SPECIFICATION REVIEWS

PUSHING THE ENVELOPE
BE COMMISSIONING

DRAWINGS REVIEW

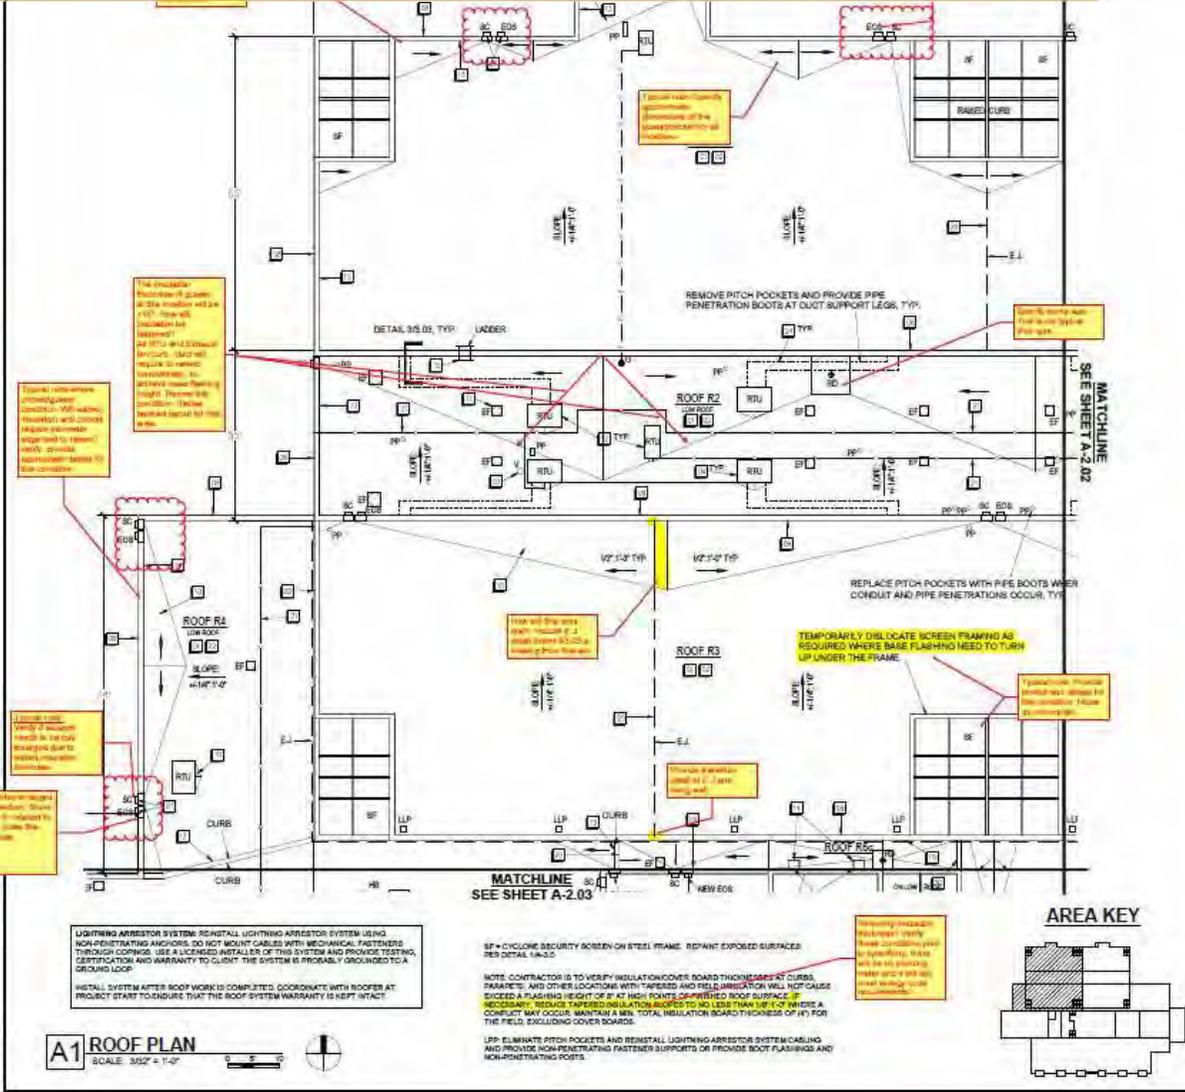
Note: drawings do not indicate there

Suggest incorporate of insulation with staggered per requirements

Incorporate FM criteria FM 1-135 in corner as shown on drawings, so that base specification 075200 and alternate specification 075410 have same performance criteria

Drawings do not show Existing LWIC. Co-ordinate specs or drawings or both

Check for pressures as shown on Drawings A 0.02. It is not co-ordinated

Incorporate appropriate FM classification per project requirements

3 LEVEL 04 - SECTION A AT CW (WEST)
1 1/2" = 1'-0"

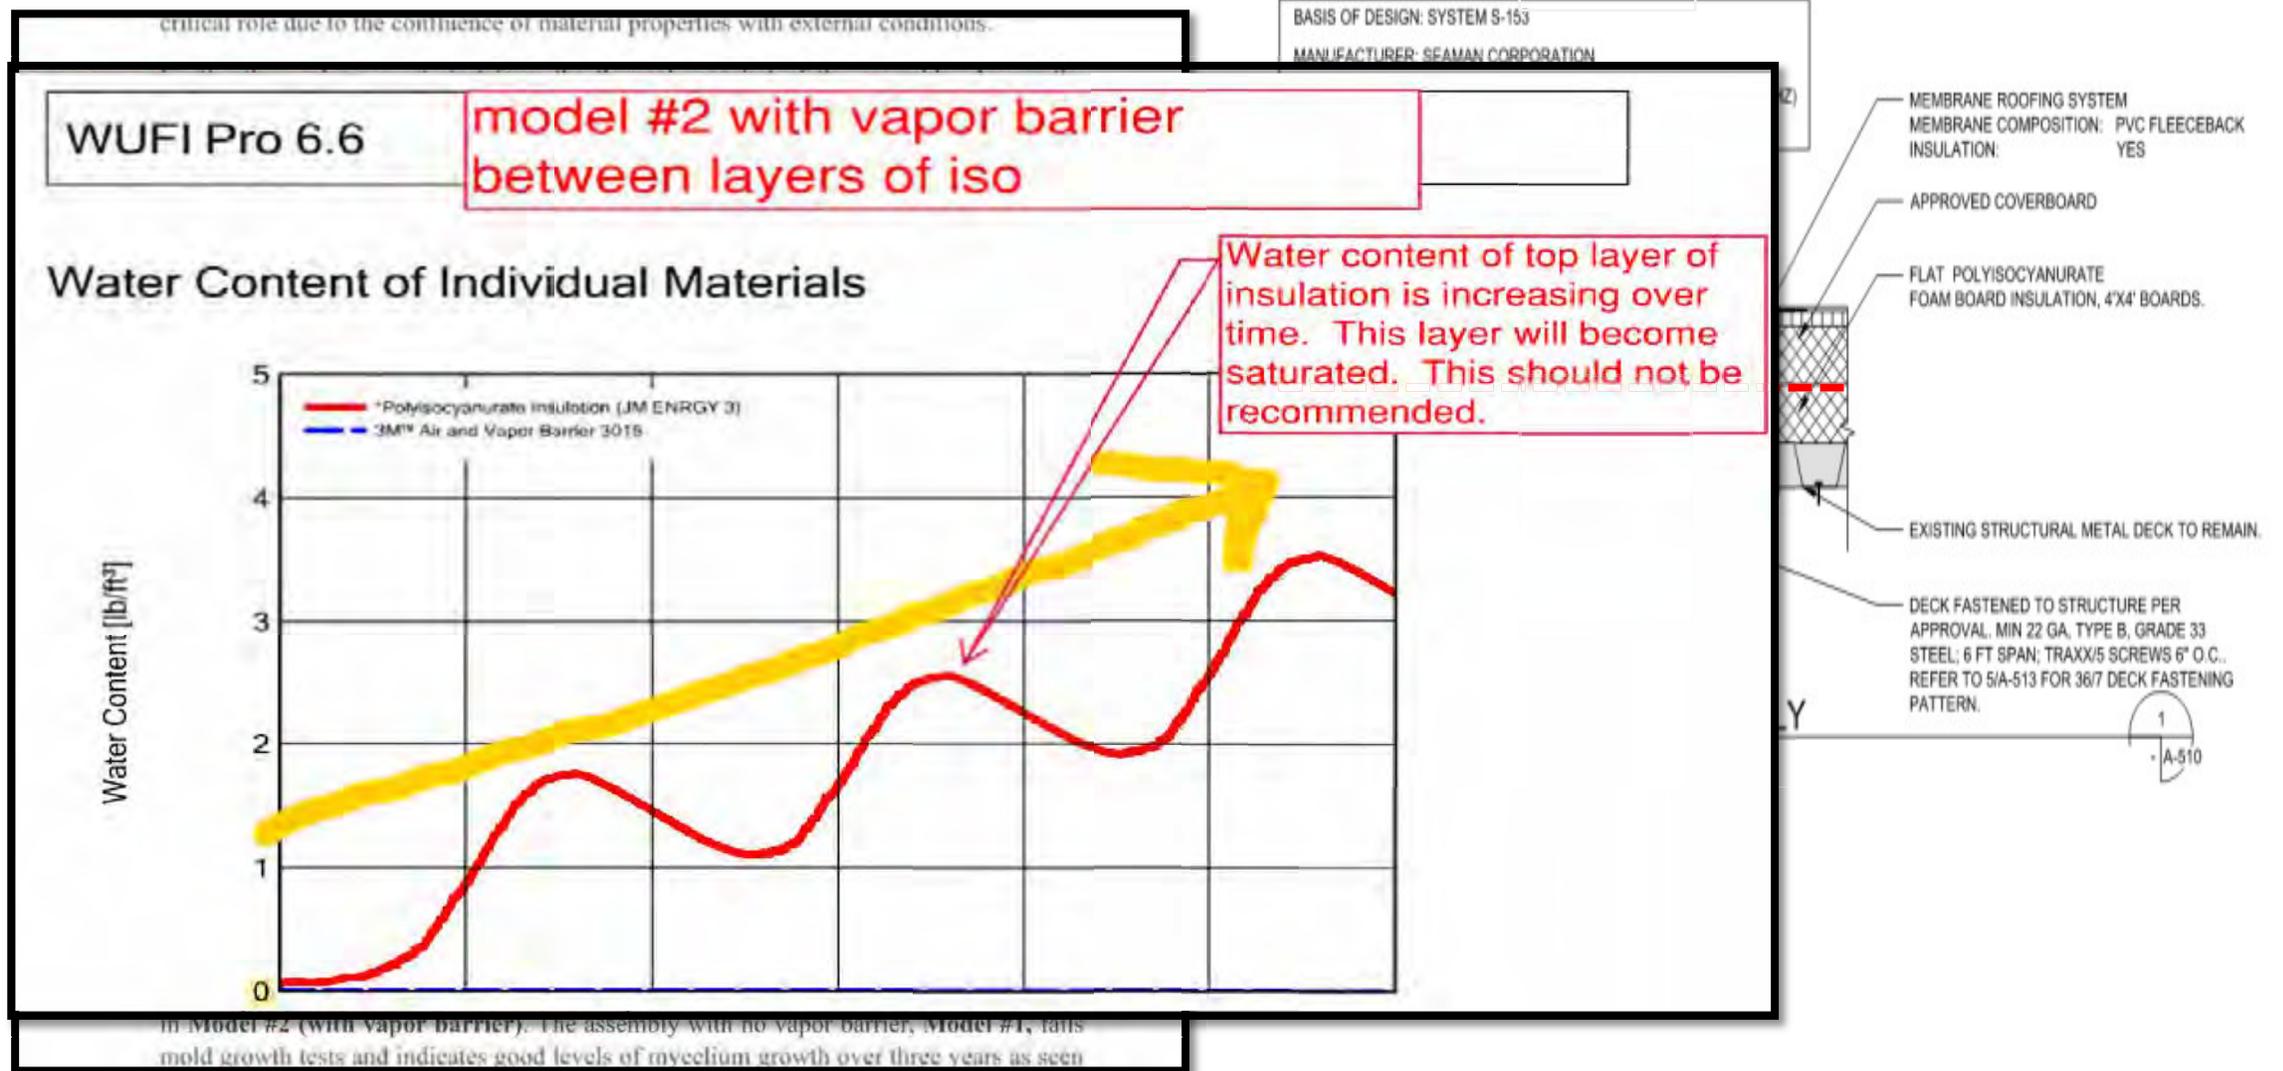
- There is no base flashing ft. Revise this detail and assembly.
- This will void roof warranty.
- How is cast stone anchored to structure. This is big span. Detail shows anchor at one locations only? Specify anchor location per structural requirements. Cast stone is shown right over roof membrane, this will void roof warranty. How will stainless steel key be sealed at roof membrane. Revise this detail. Is TPO appropriate for this application?

- Refer to TNBA document from BIA.org providing recommendation to provide control joint and expansion joint in bricks at or near corner location (20' for multiple opening) and other wall locations (Typical comment)

- Clarify if this is a clad metal for TPO. Note: Water will accumulate at this area and will fail TPO flashing eventually. Revise the detail.
- Is this parapet drip edge part of MCM panel system? How will cap flashing be installed and where is fastened to? Is there a membrane under cap flashing? Is continuous clad required?
